**STAFF REPORT**  
**KETCHUM PLANNING AND ZONING COMMISSION**  
**MEETING OF JULY 13, 2020**

- PROJECT:** 4<sup>th</sup> & Walnut Ave Commercial Development Design Review
- FILE NUMBER:** P20-046
- APPLICATION TYPE:** Design Review
- APPLICANT:** Graham Whipple, Resin Architecture
- PROPERTY OWNER:** Walnut & Fourth LLC
- LOCATION:** 371 & 391 N Walnut Avenue (Ketchum Townsite: Block 44: Lots 7 & 8)
- ZONING DISTRICT:** Retail Core Subdistrict of the Community Core (CC-1)
- NOTICE:** A public hearing notice for the project was mailed to all owners of property within 300 feet of the project site on June 26<sup>th</sup>, 2020. The Planning & Building Department has received no public comment as of the publication of the Staff Report. Public comment received after the Staff Report’s publication will be forwarded to the Planning & Zoning Commission and included in the project record.
- REVIEWER:** Abby Rivin, Associate Planner

**NEW MIXED-USE BUILDING AT CORNER OF 4<sup>th</sup> & WALNUT**

Figure 2: NE Elevation (Walnut)--Project Plans Sheet A-201

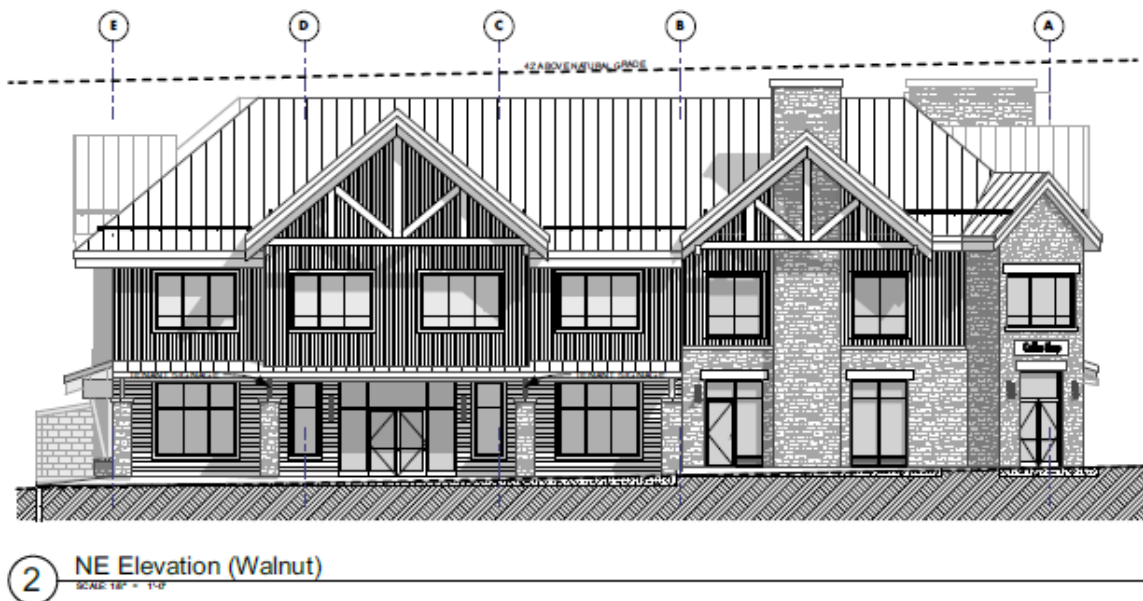
The 42-foot tall building’s gross floor area is 20,876 square feet with a total Floor Area Ratio of 1.28. The building spans approximately 93 feet along Walnut Avenue and 140 feet along 4<sup>th</sup> Street. The development’s scale is contextually appropriate and proportional to the size of buildings in downtown Ketchum. In the Retail Core, buildings may extend all the way to the front and street side property lines. While not required by the CC-1 dimensional standards, the proposed building is setback from 4<sup>th</sup> Street and Walnut Avenue. Most of the building frontage along 4<sup>th</sup> Street is setback 5 feet and most of the front façade along Walnut Avenue is setback 10 feet. This setback area provides flexible outdoor space on-site to accommodate outdoor dining as illustrated on the renderings (Exhibit A: Sheets A-301 & A-302).

**FIRST FLOOR PLAN**  
7/6/20  
**4th & Walnut Ave.**  
Commercial Development  
Design Review July 13th 2020  
A-102

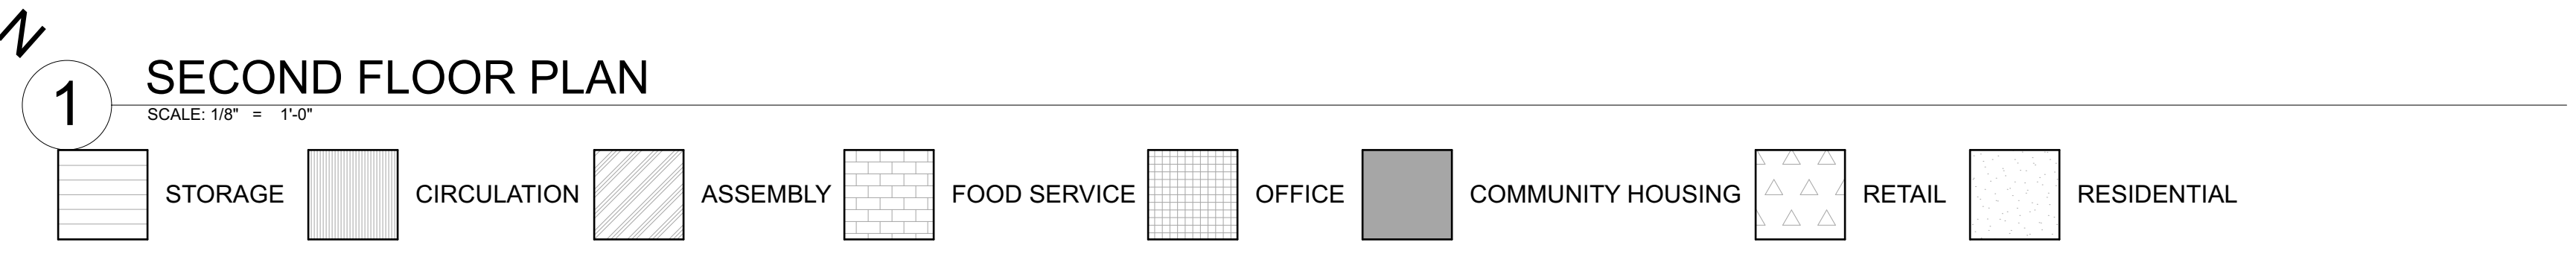
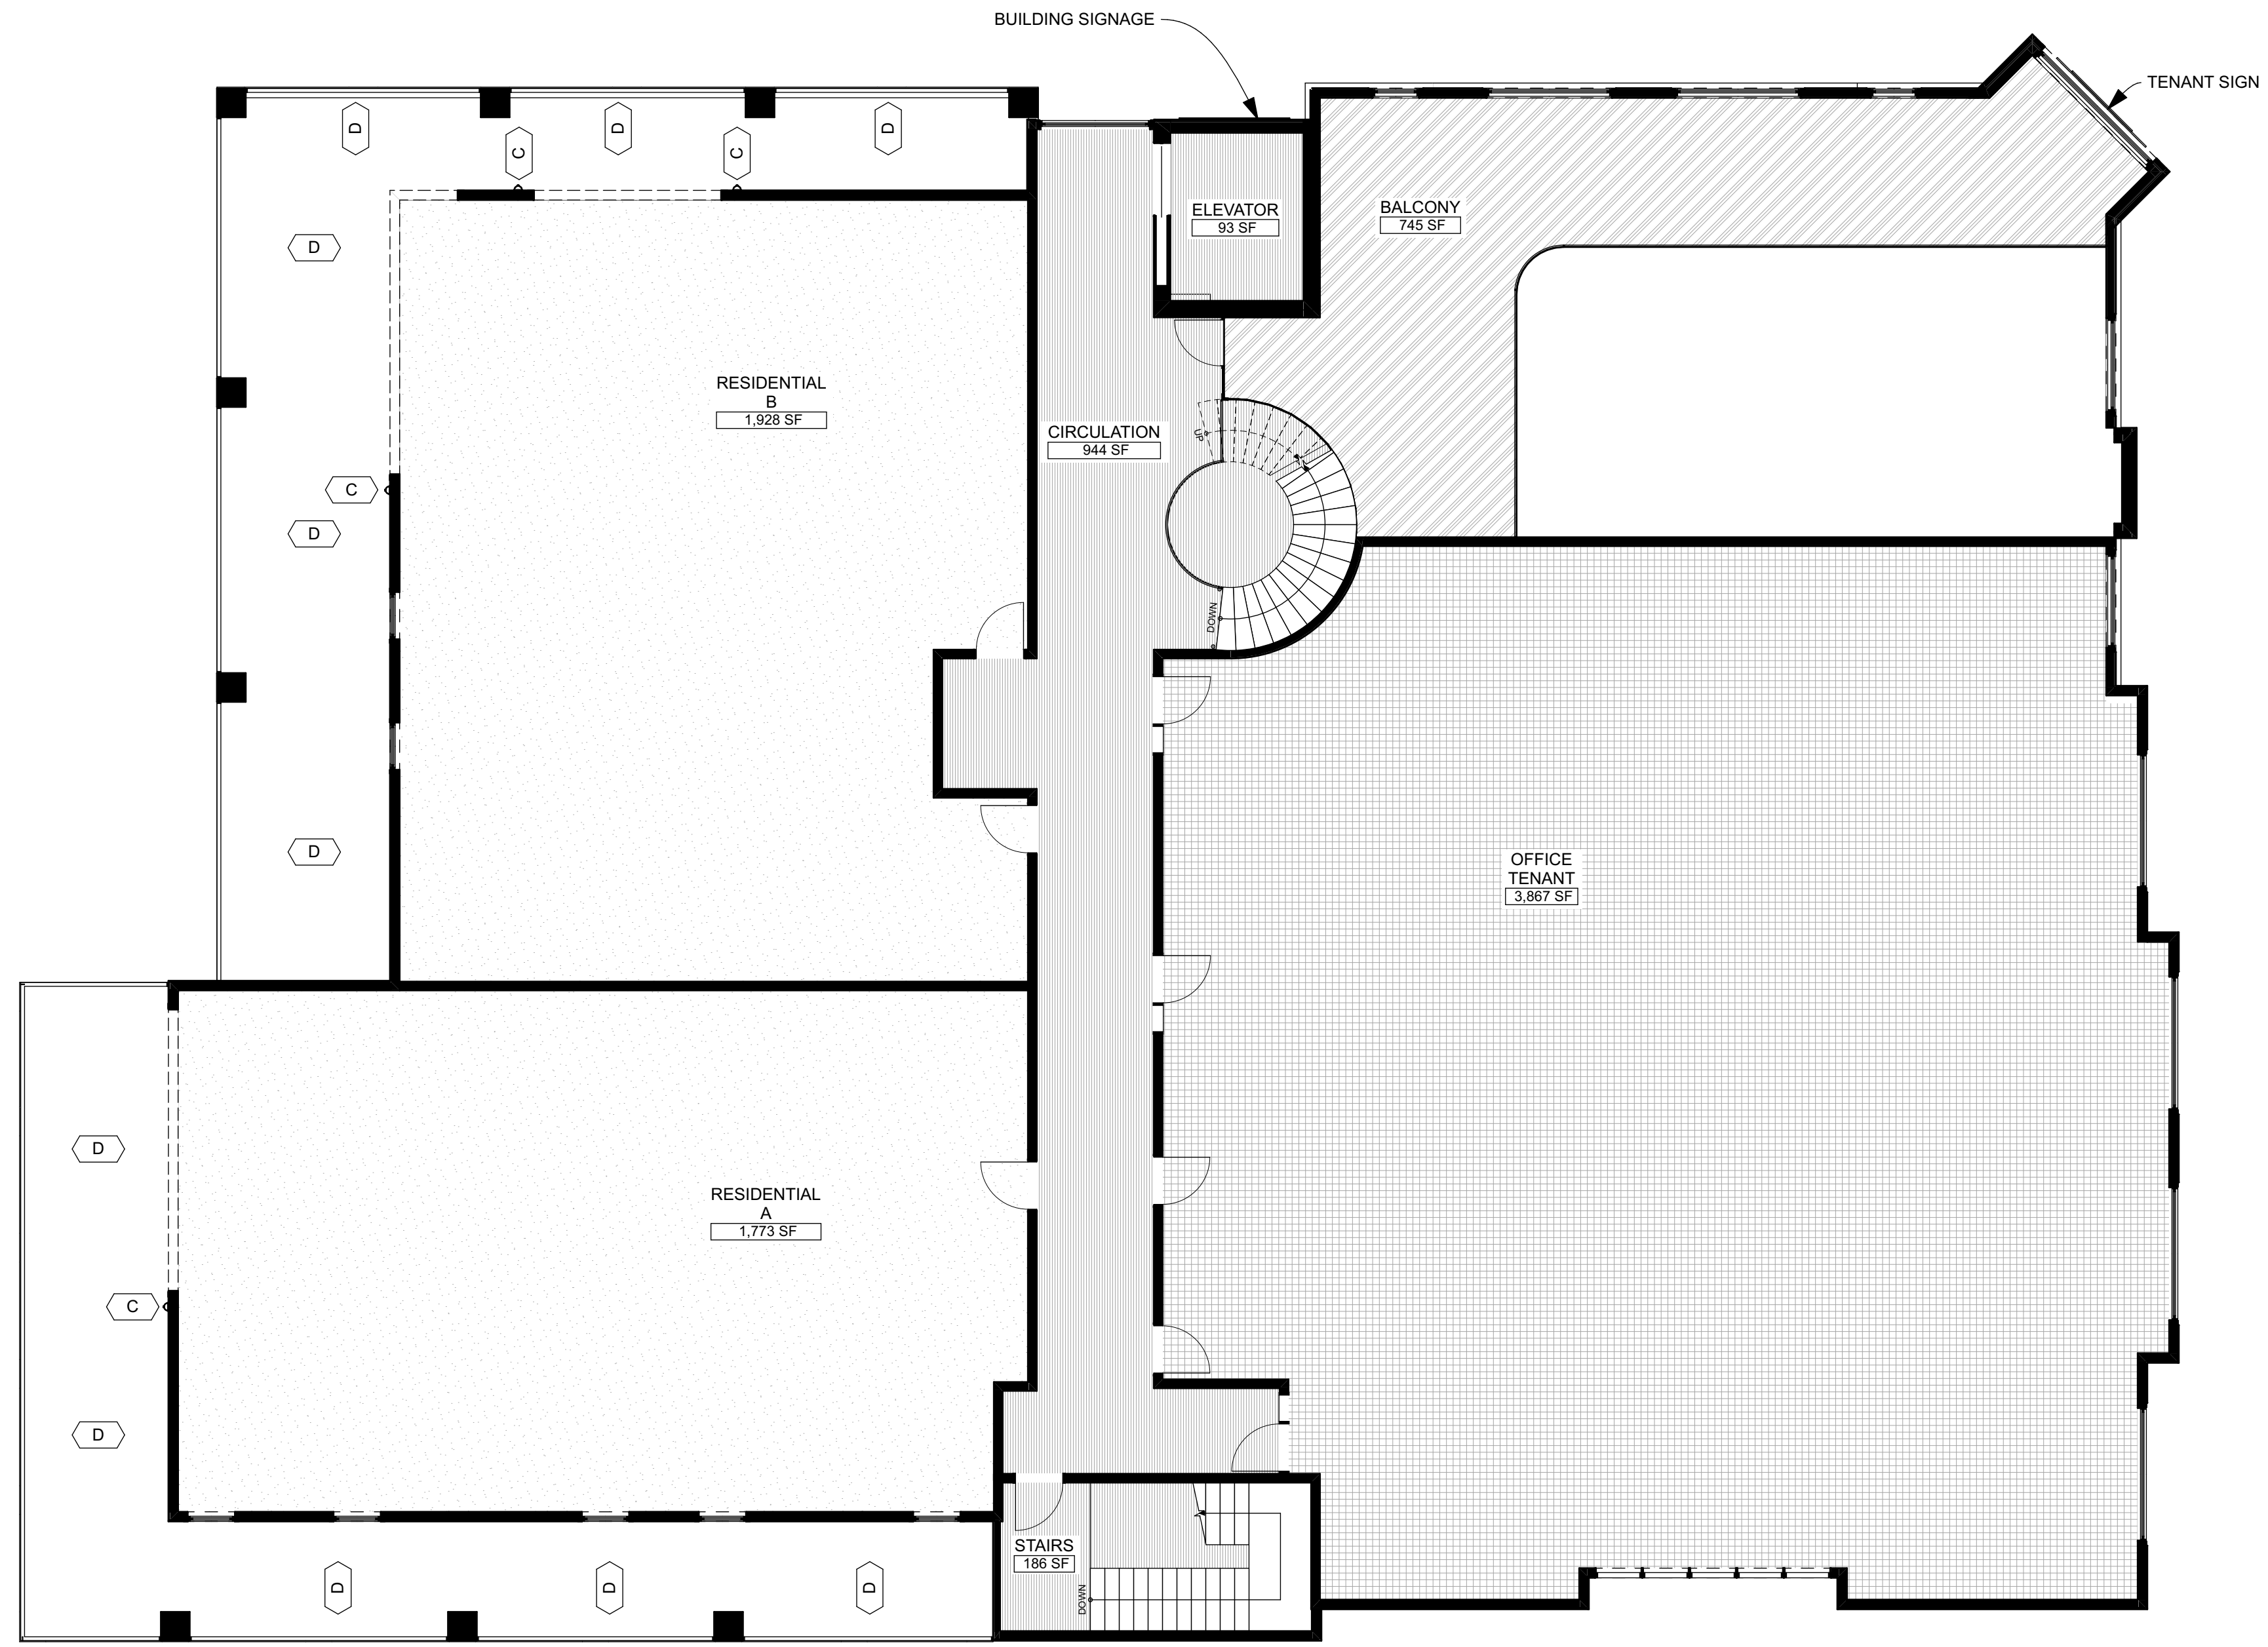
<i>Staff Comments</i>	<p>All utilities within the development site shall be underground and concealed from public view. The Architectural Site Plan (Sheet AS-101), First Floor Plan (A-102), and Alley Elevation (Sheet A-202) of the project plans indicate the electrical utility enclosure. The Architectural Site Plan (Sheet AS-101) indicates that the transformer serving the development will be located at the back of the building adjacent to the Block 44 alleyway and fully concealed from public view.</p> <p>An existing overhead power line runs along the Block 44 alleyway adjacent to the subject property. The project plans indicate that this power line will be buried underground.</p>
<input checked="" type="checkbox"/>	<input type="checkbox"/>	<input checked="" type="checkbox"/>	17.96.060.D3 Utilities	<p>When extension of utilities is necessary all developers will be required to pay for and install two (2") inch SDR11 fiber optical conduit. The placement and construction of the fiber optical conduit shall be done in accordance with city of Ketchum standards and at the discretion of the City Engineer.</p>

**2** SW Elevation (Alley)  
SCALE: 1/8" = 1'-0"

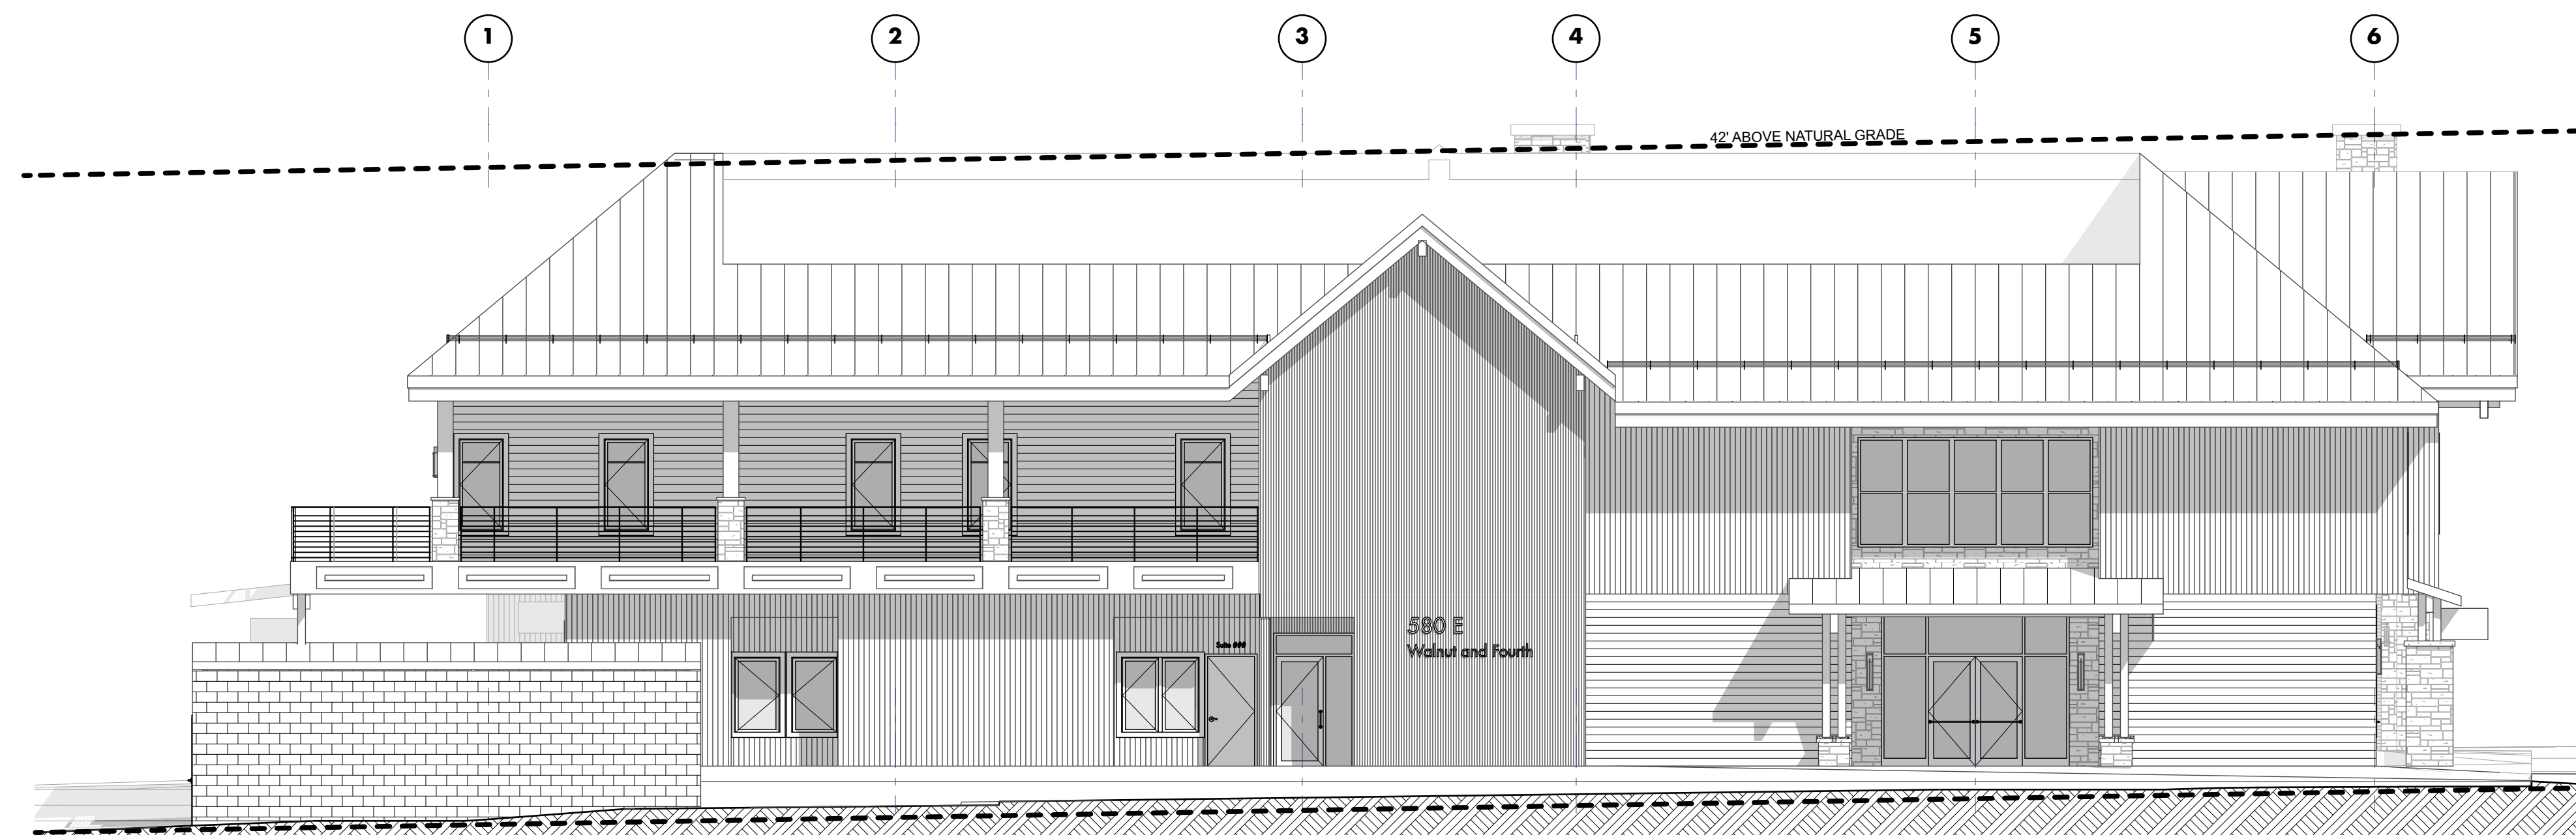
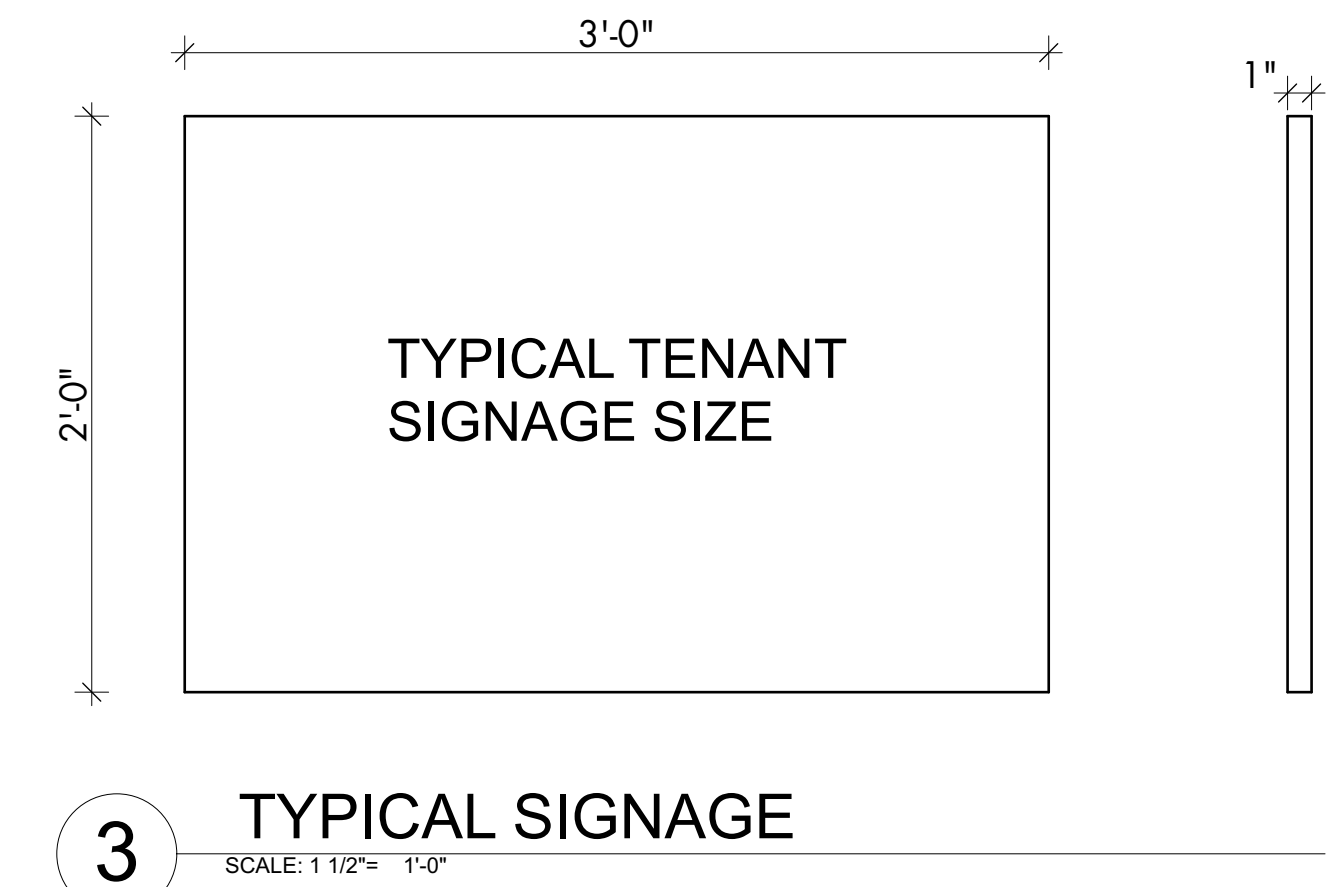
Staff Comments	<i>The proposed roof is a false mansard. As illustrated on the southeast elevation indicated on Sheet A-202, the top of the mansard roof falls into a 10-foot deep recessed area that is fully screened from public view. All roof-mounted mechanical, plumbing, and electrical equipment is contained within this fully screened, false mansard recession. The applicant has also proposed a roof-mounted solar system contained within this recession.</i>  <i>All utilities within the development site shall be underground and concealed from public view. The Architectural Site Plan (Sheet AS-101), First Floor Plan (A-102), and Alley Elevation (Sheet A-202) of the project plans indicate the electrical utility enclosure. The Architectural Site Plan (Sheet AS-101) indicates that the transformer serving the development will be located at the back of the building adjacent to the Block 44 alleyway and fully concealed from public view.</i>  <i>An existing overhead power line runs along the Block 44 alleyway adjacent to the subject property. The project plans indicate that this power line will be buried underground.</i>  <i>All roof and ground mounted mechanical and electrical equipment shall be fully screened from public view. The final screening, location, and height of all ground and roof mounted mechanical equipment shall be reviewed prior to the issuance of a building permit and shall be approved upon final inspection prior to Certificate of Occupancy for the project.</i>
